X3T9.2/87-62

Listed below are all the items that were involved in up-dating the ANSI X3.91M-1982 Storage Module Interface standard. As you will notice, a better dressing-up of the drawings now exists as well as better defining hole dimensions for hardware jackscrew guides and pin sockets. I believe also that these drawings as revised, better represent a more generic approach to the SMD Industry.

AMERICAN NATIONAL STANDARD X3.91M-1982

Fig. 3
CONTROL Round Cable Connectors

FIG-3
P. 2

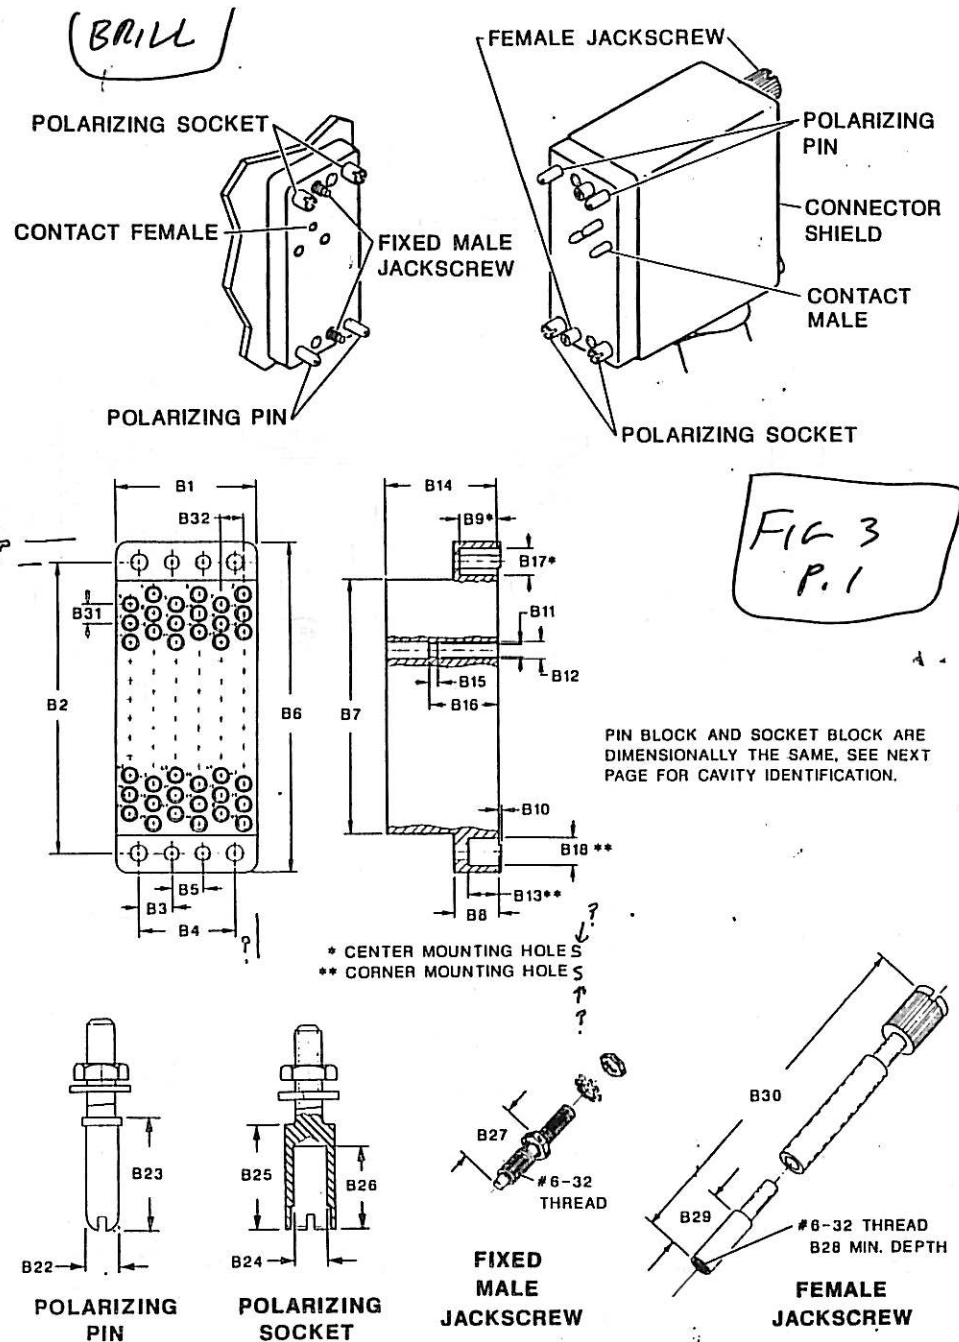
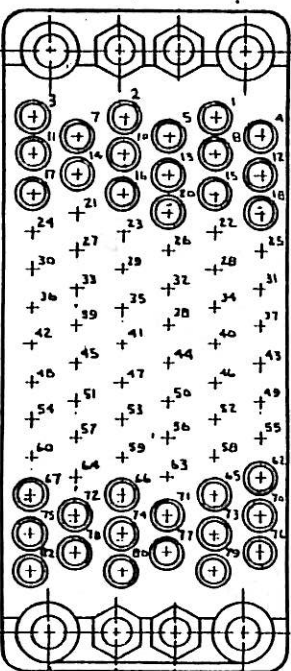
- b₂₄ deleted (outside edge)
- b₂₅ became B2
- b₂₆ became B5 (changed to .001)
- b₂₇ became B3 (changed to .001)
- b₂₈ became B4 (old drawing should have been B6)
- b₂₉ deleted (outside of block)
- b₃₀ became B6
- b₃₁ became B19
- b₃₂ became B20
- b₃₃ became B21
- b₃₄ deleted (replaced by B23; added B22 dia.)
- b₃₅ deleted (replaced by B27)
- b₃₆ became B30 (added in B29 min. thread depth)

NOTE CHANGES
IN THESE COLUMNS
IN BRILL'S NEW
FIGURES
(SEE COVER LETTER)

DIMENSIONS	INCHES	MILLIMETERS
B1	1.110	28.19
B2	2.281	57.94
B3	.266	6.75
B4	.766-?	19.45 -?
B5	.234	5.94
B6	2.595?	65.91?
B7	1.983	50.37
B8	.365	9.27
B9	.300	7.62
B10	.011*	0.28*
B11	.115	2.92
B12	.131	3.33
B13	.250	6.35
B14	.915	23.24
B15	.054	1.37
B16	.554	14.07
B17	.195	4.95
B18	.234†	5.94†
B19	.797	20.24
B20	.062†	1.57†
B21	.529	13.44
B22	.130 Max.†	3.30 Max.†
B23	.440	11.17
B24	.133†	3.38†
B25	.405	10.29
B26	.330	8.38
B27	.465	11.81
B28	.312	7.92
B29	.485	12.32
B30	2.305	58.55
B31	.150*	3.81*
B32	.180*	4.57*

FIG-6
A.2

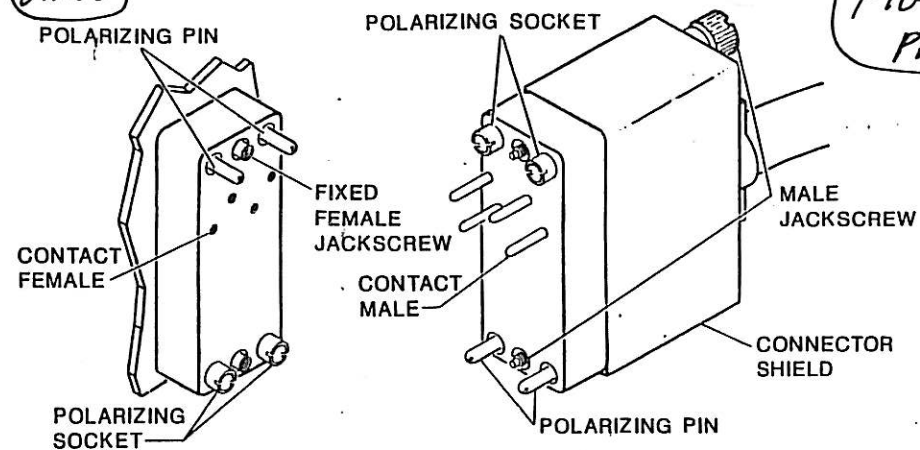
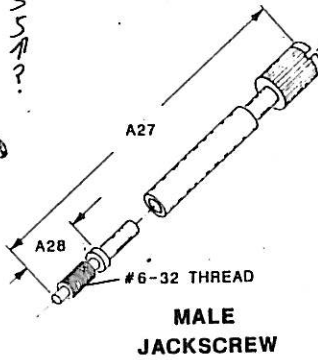
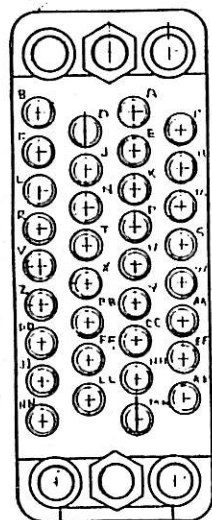
- a₂ deleted (not critical)
- a₃ became A2 (correction) (no difference; 1.687 O.K.)
- a₄ became A3
- a₅ became A4
- a₆ became A5
- a₇ deleted (not critical)
- a₈ became A14
- a₉ became A19
- a₁₀ became A7
- a₁₁ became A6 (changed by .002)
- a₁₂ became A13 (changed by .002)
- a₁₃ became A12
- a₁₅ became A6
- a₁₆ became A7
- a₁₇ became A10
- a₁₈ became A11
- a₁₉ deleted (same as A7)
- a₂₀ same as A1
- a₂₁ deleted (same as A2)

- a₂₂ same as A5
- a₂₃ same as A3
- a₂₄ same as A4
- a₂₅ same as A2
- a₂₆ same as A29
- a₂₇ same as A30
- a₂₈ same as A31
- a₂₉ deleted (replaced by A26 by adding in male and female socket same as B drawing)
- a₃₀ became A27 (changed old A30 - error)
- a₃₁ added in polarizing pin and socket
- b₁ deleted (hole to outside edge)
- b₂ became B1
- b₃ became B6
- b₄ became B5 (changed to .001)
- b₅ deleted (to the edge)
- b₆ became B4 (.019 difference - error)
- b₇ became B3 (changed by .001)
- b₈ became B2
- b₉ deleted (calling out depth of hole in guide hardware)
- b₁₀ became B14 (B9 and B10 in old document revised)
- b₁₁ became B10
- b₁₂ deleted (same as B9)
- b₁₃ became B8
- b₁₄ became B7
- b₁₅ became B11
- b₁₆ became B14
- b₁₇ became B7
- b₁₈ became B8
- b₁₉ became B10
- b₂₀ became B16
- b₂₁ became B15
- b₂₂ became B12 (changed to .002)
- b₂₃ became B1

NOTE CHANGES IN
THESE COLUMNS IN
BRILL'S NEW
FIGURES
(see cover letter)

DIMENSIONS	INCHES	MILLIMETERS
A1	.750	19.05
A2	1.686 ~ ?	42.85
A3	.234	5.94
A4	.468	11.89
A5	2.000	50.80
A6	1.411	35.84
A7	.365	9.27
A8	.250	6.35
A9	.218†	5.54†
A10	.554	14.07
A11	.054	1.37
A12	.115	2.92
A13	.131	3.33
A14	.915	23.24
A15	.300	7.62
A16	.195	4.95
A17	.150*	3.81*
A18	.180*	4.57*
A19	.011*	.28*
A20	.130Max.†	3.30Max.†
A21	.440	11.17
A22	.141†	3.58
A23	.405	10.29
A24	.330	8.38
A25	.312	7.92
A26	.485	12.32
A27	2.285	58.04
A28	.465	11.81
A29	.797	20.24
A30	.062†	1.57
A31	.529	13.44
